Plat Name: Edgewood Plat #: 220100340

Plat Details: R-60 zone; 1 lot

MINOR SUBDIVISION PLAT REVIEW SHEET

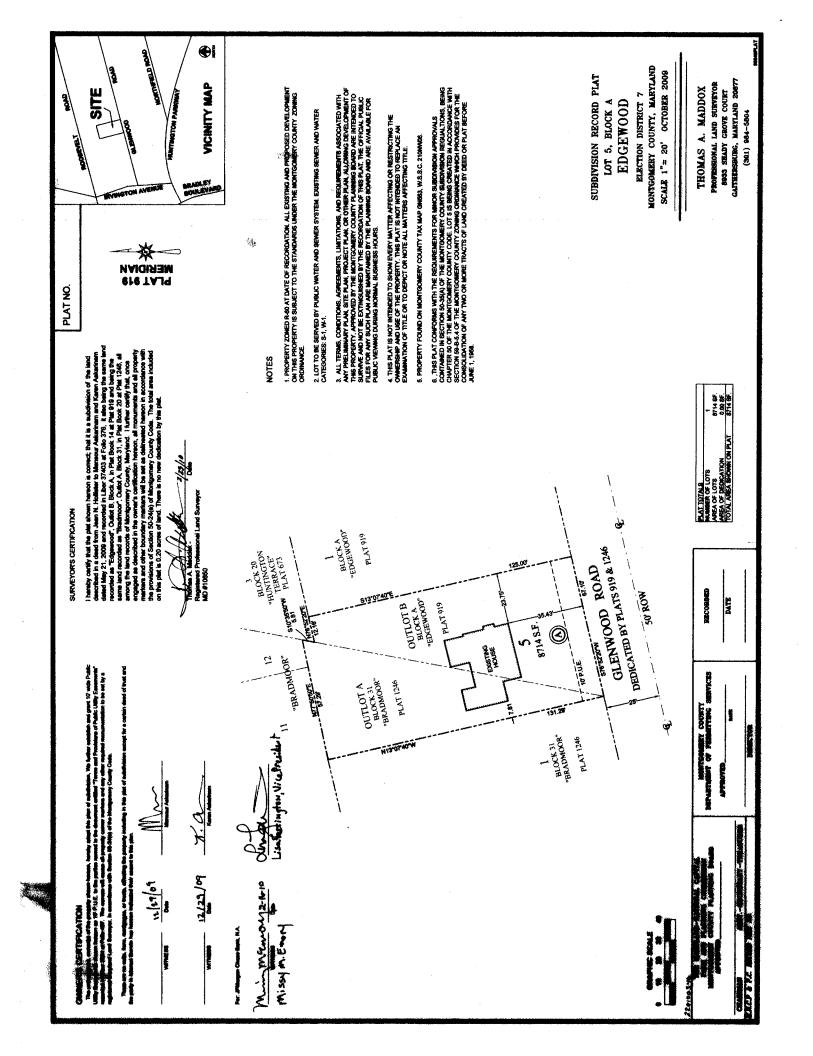
Staff recommends approval of this minor subdivision plat pursuant to Section 50-35A (a)(3) of the Subdivision Regulations, which states:

Staff applied the above-noted minor subdivision criteria for this property and concludes that the proposed subdivision complies with the requirements of Section 50-35A(a)(3) and supports this minor subdivision record plat.
